## PIC24FJ256GB210 Family Silicon Errata and Data Sheet Clarification

The PIC24FJ256GB210 family devices that you have received conform functionally to the current Device Data Sheet (DS39975A), except for the anomalies described in this document.

## Data Sheet Clarifications

The following typographic corrections and clarifications are to be noted for the latest version of the device data sheet (DS39975A):

**FIGURE 2-3 FREQUENCY vs. ESR PERFORMANCE FOR SUGGESTED VCAP**

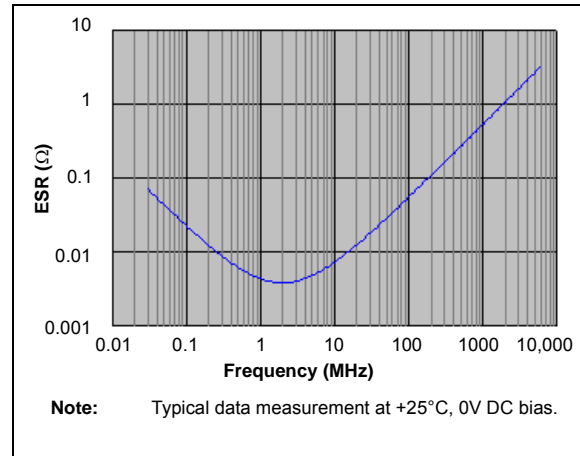
Section 2.4 “Voltage Regulator Pins (ENVREG and VCAP)” has been replaced with a new and more detailed section. The entire text follows:

When the regulator is enabled, a low-ESR ( $< 5\Omega$ ) capacitor is required on the VCAP pin to stabilize the voltage regulator output voltage. The VCAP pin must not be connected to VDD and must use a capacitor of 10  $\mu\text{F}$  connected to ground. The type can be ceramic or tantalum. Suitable examples of capacitors are shown in [Table 2-1](#). Capacitors with equivalent specifications can be used.

Designers may use [Figure 2-3](#) to evaluate ESR equivalence of candidate devices.

The placement of this capacitor should be close to VCAP. It is recommended that the trace length not exceed 0.25 inch (6 mm). Refer to **Section 29.0 “Electrical Characteristics”** for additional information.

**FIGURE 2-4 DC BIAS VOLTAGE vs. CAPACITANCE CHARACTERISTICS**

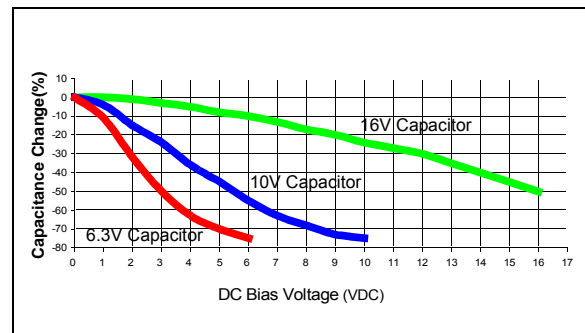
In addition to temperature tolerance, the effective capacitance of large value ceramic capacitors can vary substantially, based on the amount of DC voltage applied to the capacitor. This effect can be very significant, but is often overlooked or is not always documented.

A typical DC bias voltage vs. capacitance graph for 16V, 10V and 6.3V rated capacitors is shown in Figure 2-4.

When selecting a ceramic capacitor to be used with the internal voltage regulator, it is suggested to select a high-voltage rating, so that the operating voltage is a small percentage of the maximum rated capacitor voltage. For example, choose a ceramic capacitor rated at 16V for the 1.8V core voltage. Suggested capacitors are shown in Table 2-1.

**FIGURE 29-1: PIC24FJ256GB210 FAMILY VOLTAGE-FREQUENCY GRAPH (INDUSTRIAL)**

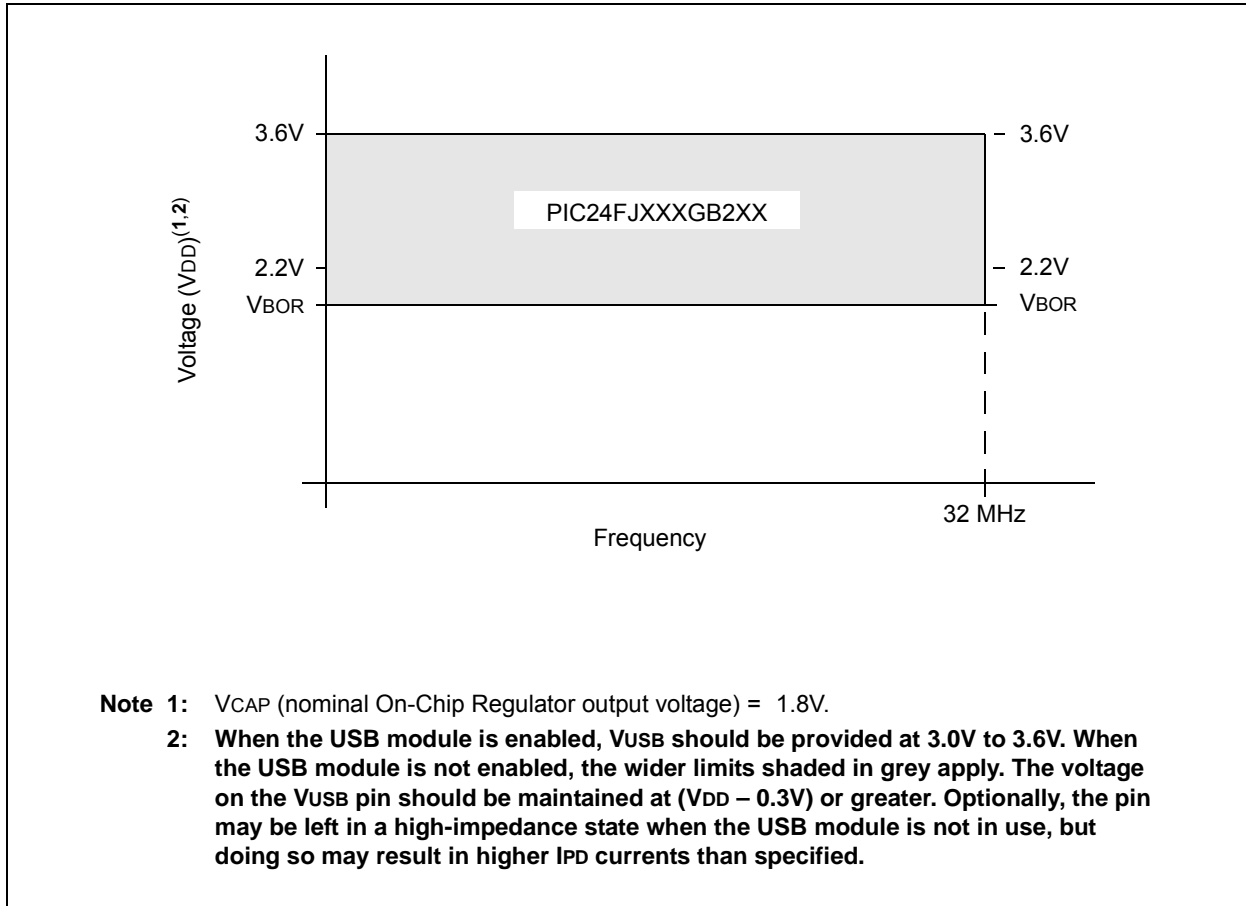
Figure 29-1 (“PIC24FJ256GB210 Family Voltage-Frequency Graph”) is amended by adding an additional footnote. The updated figure is shown below (changes in **bold**; bold in original removed for clarity).
